Title - Sujet Sewage Lagoon Rehabilitation	
Solicitation No. - N° de l'invitation EZ899-161731/A	Amendment No. - N° modif. 002
Client Reference No. - N° de référence du client	Date 2015-12-23
GETS Reference No. - N° de référence de SEAG PW-\$PWY-019-7688	
File No. - N° de dossier PWY-5-38302 (019)	CCC No./N° CCC - FMS No./N° VME
Solicitation Closes - L'invitation prend fin at - à 02:00 PM on - le 2016-01-05	
F.O.B. - F.A.B. Plant-Usine: <input type="checkbox"/> Destination: <input checked="" type="checkbox"/> Other-Autre: <input type="checkbox"/>	
Address Enquiries to: - Adresser toutes questions à: Ngan, Ken (PWY)	Buyer Id - Id de l'acheteur pwy019
Telephone No. - N° de téléphone (604) 658-2755 ()	FAX No. - N° de FAX (604) 775-6633
Destination - of Goods, Services, and Construction: Destination - des biens, services et construction: Parks Canada - Pacific Rim National Park - Ucluelet, BC

Please find following Addendum #1.

The following changes / clarifications in the tender documents are effective immediately. This Addendum will form part of the Contract Documents.

Figure 3.3 Typical Silt Fence Construction and Applications

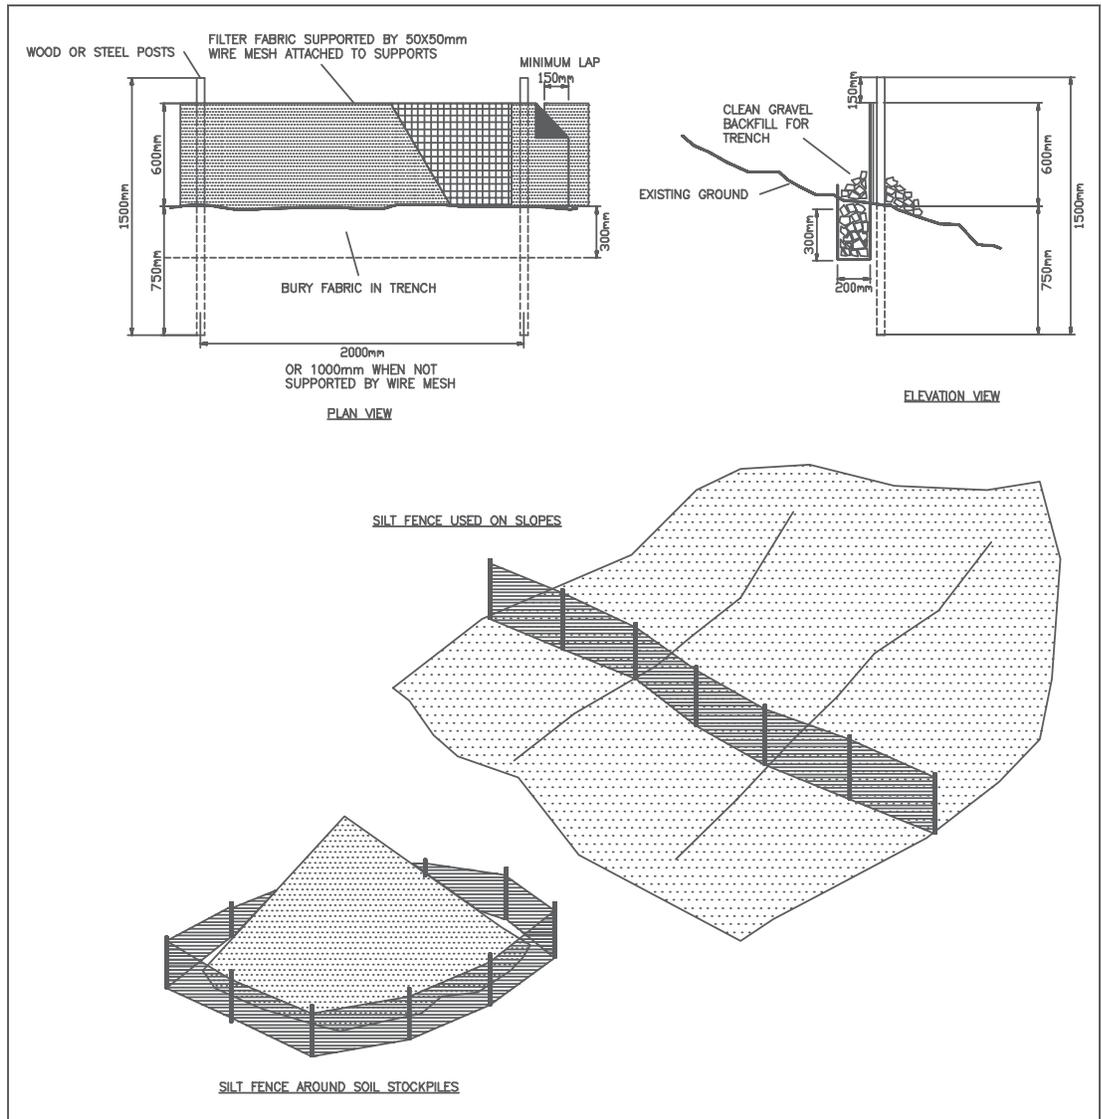
24. In the construction sediment management plan under force main clearing (from Ocean trail to west bank of Sandhill main stem). It states to install sediment control (“at western Sandhill tributary and throughout wet land bog areas as required”) can you clarify what measures and materials needed are to be taken? It is unclear to us as to what measures would be acceptable for the entire clearing area’s and to what extent; during site visit area was very wet. (Drawing and distances of types of sediment control?)

No significant sediment control measures within the wet land bog itself are expected. Sediment control at each of the stream crossings as well as the eastern and western edges of the bog may include the use of silt fences installed at the top of bank as well as the high water mark. They will

be installed 1.0-2.0m greater than the width of the work area running parallel the watercourse. These structures may be accompanied by covering any erodible soils with straw.

A drawing of a typical silt fence is attached to this Addendum for reference.

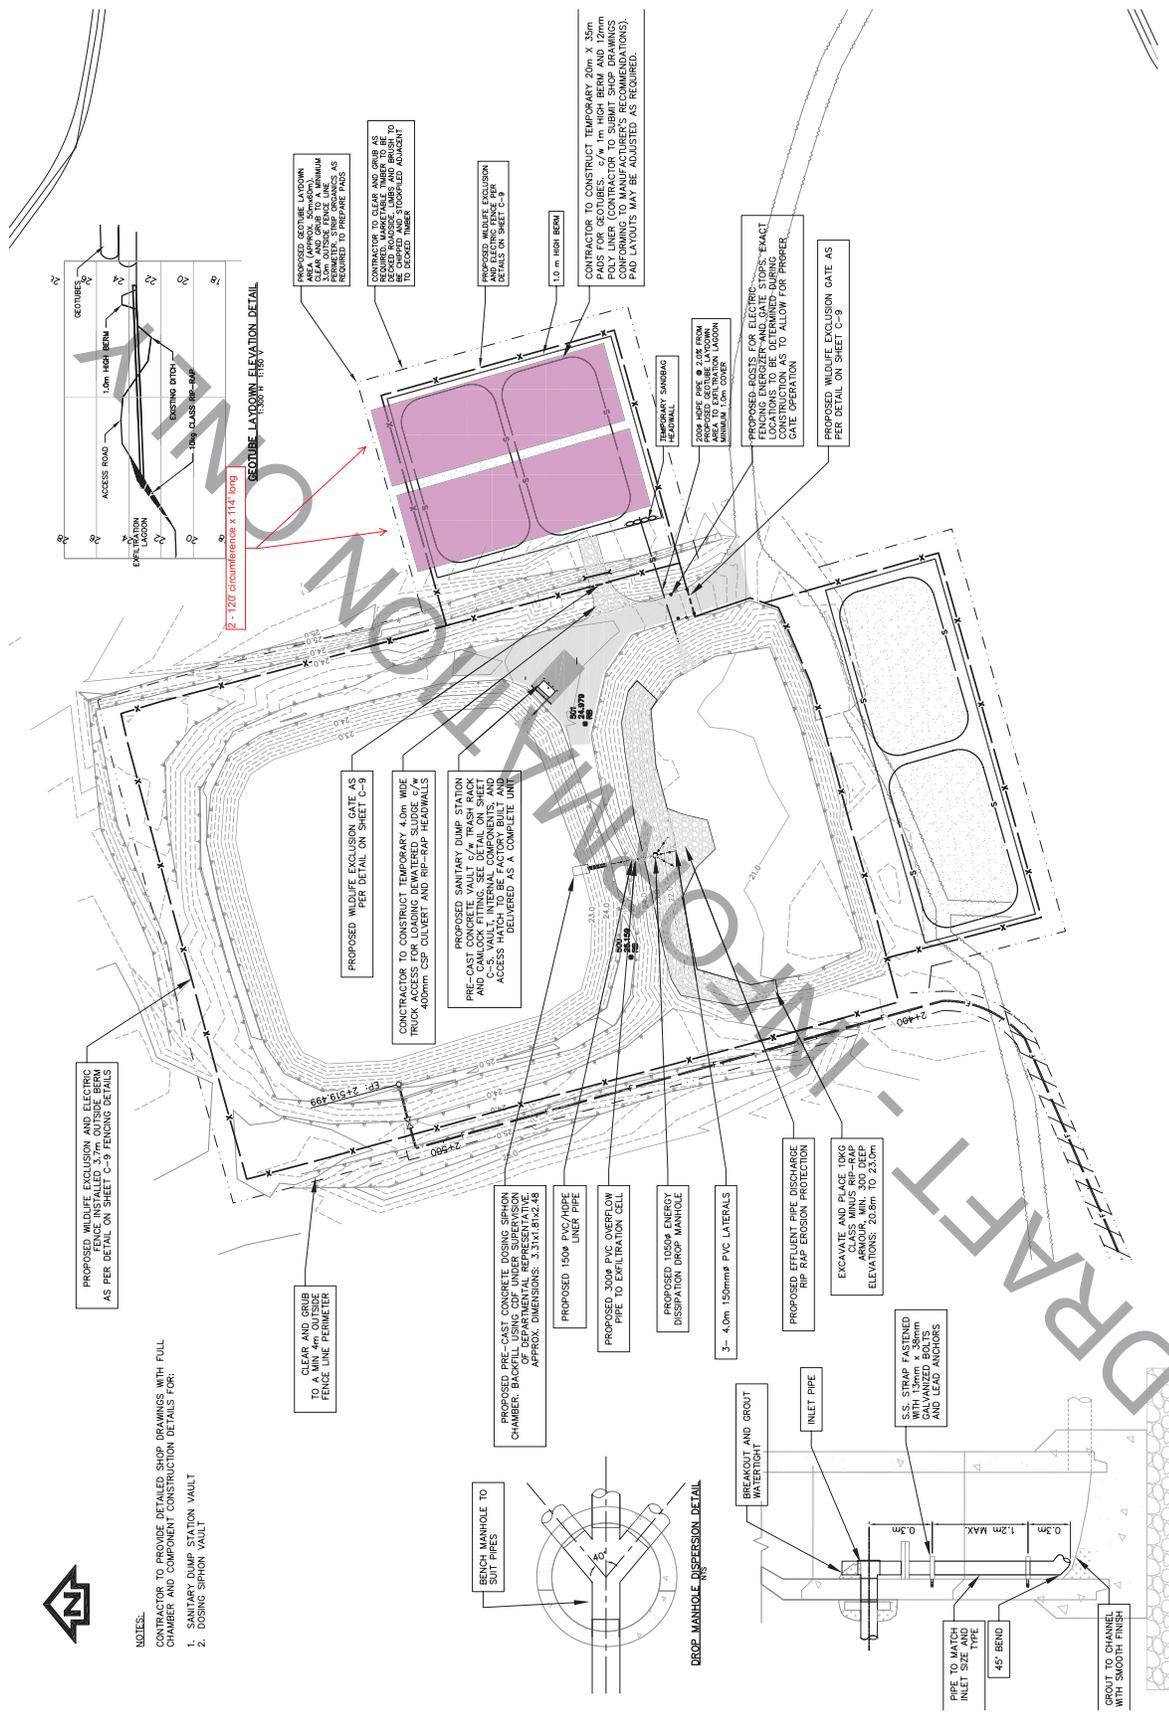
3. *The laydown area shown on the drawings will accommodate 4 – 60' x 100' Geotubes. From the volume derived from the sludge survey conducted, and the percent solids of the sludge, it would appear that there could be need for up to 6 Geotubes. Is there allowance to extend the proposed laydown area to accommodate additional tubes, or is it to be confined to the area shown on the drawings?*

6. Can we reuse the material from the site activities to build berm around geo bags? Or are we to import material? If so what type of material?

Contractors to allow for the modification of the proposed laydown area from 40m x 35m to 38m x 39m in bids. Geotube sizes and alignment may be adjusted to enable all removed sludge to be retained within this area. Clearing & Grubbing limits and fence alignment to be adjusted as

required. Contractor to submit proposed layout prior to construction for approval. No additional payment will be made for these revisions.

Refer to: Contract Drawing Sheet C-3 "Contractor to construct temporary 20m x 35m pads for Geotubes. c/w 1m high berm and 12mm poly liner (Contractor to submit shop drawings conforming to Manufacturer's Recommendations). Pad layouts may be adjusted as required."

It is expected that material generated from onsite activities will conform to Manufacturer's Recommendations as long as it is void of substantial organics and adequately compacted.
